MILITARY SPECIFICATION

CONNECTOR, ELECTRICAL, RECEPTACLE: 10526125

This amendment forms a part of Military Specification MIL-C-60174(MU), dated 19 March 1965.

FIGURE 1 MECHANICAL GAGE

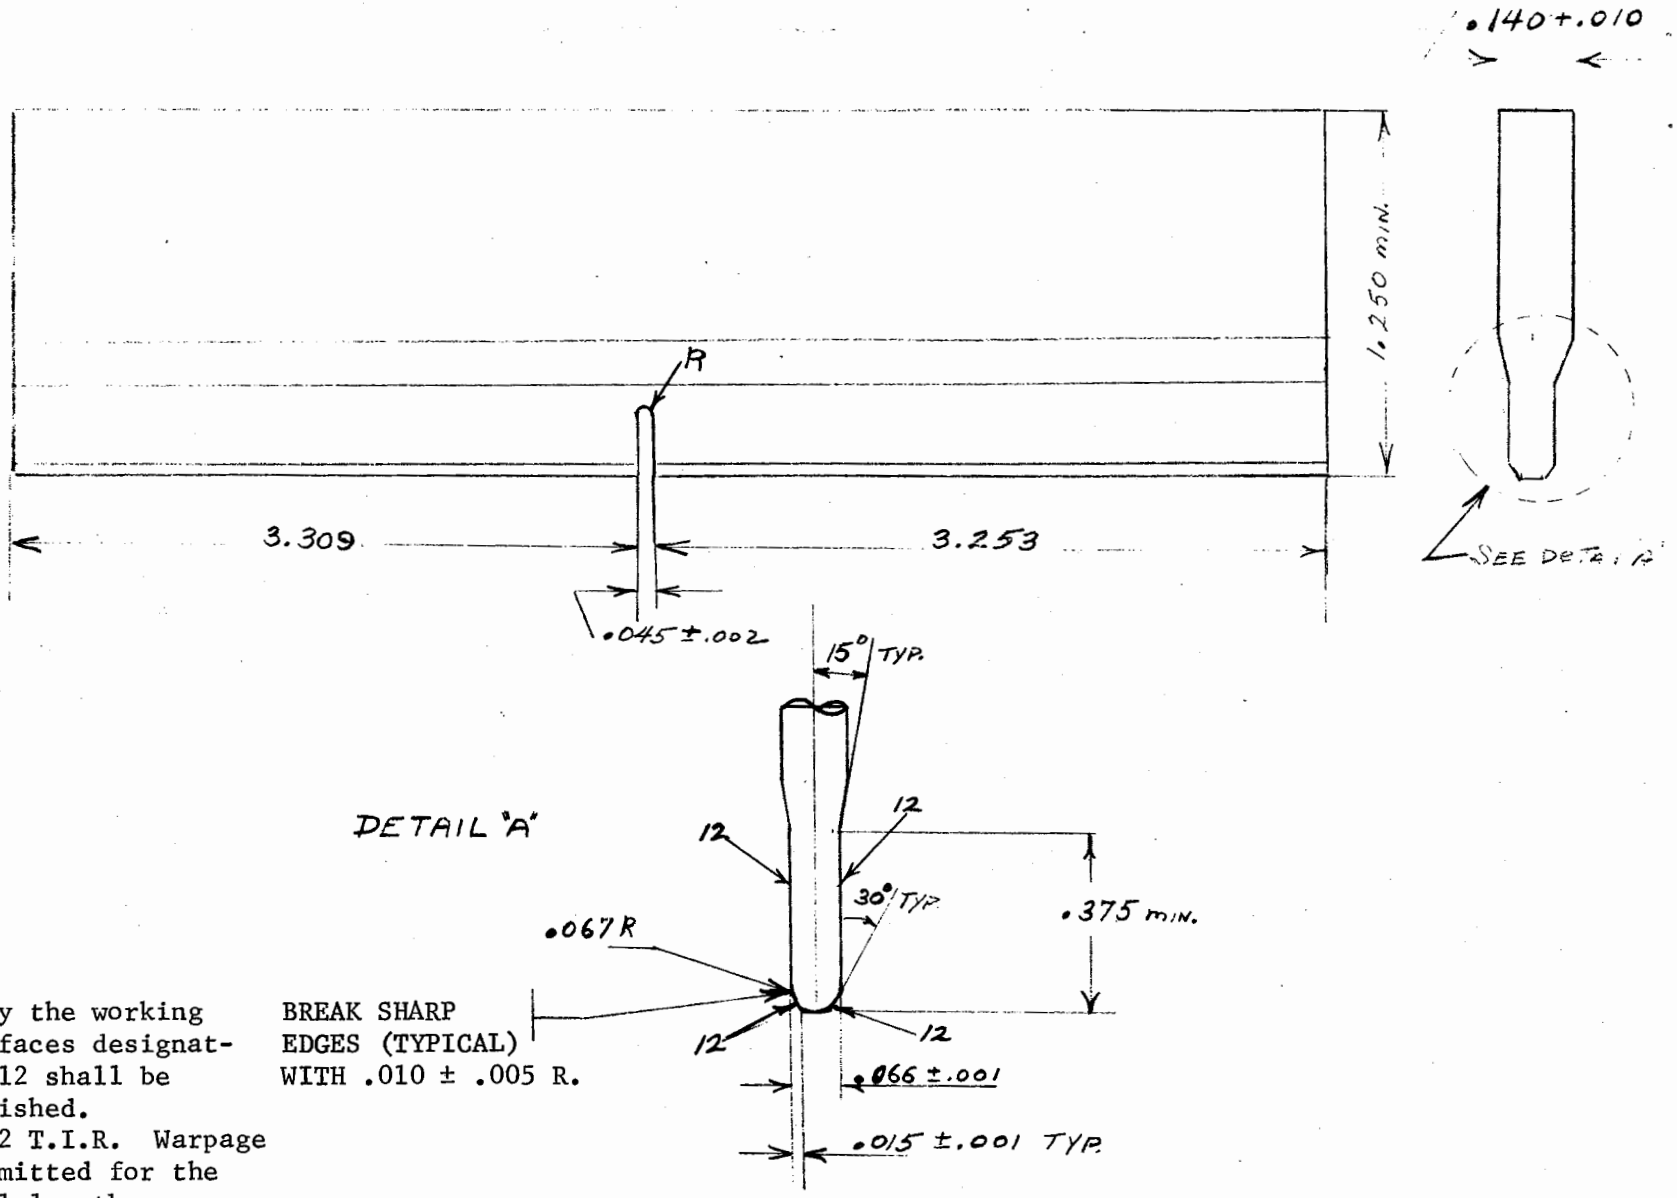
Add "Item 10 Steel Gage - Outline as shown in Figure 1".

Add: Figure 1.
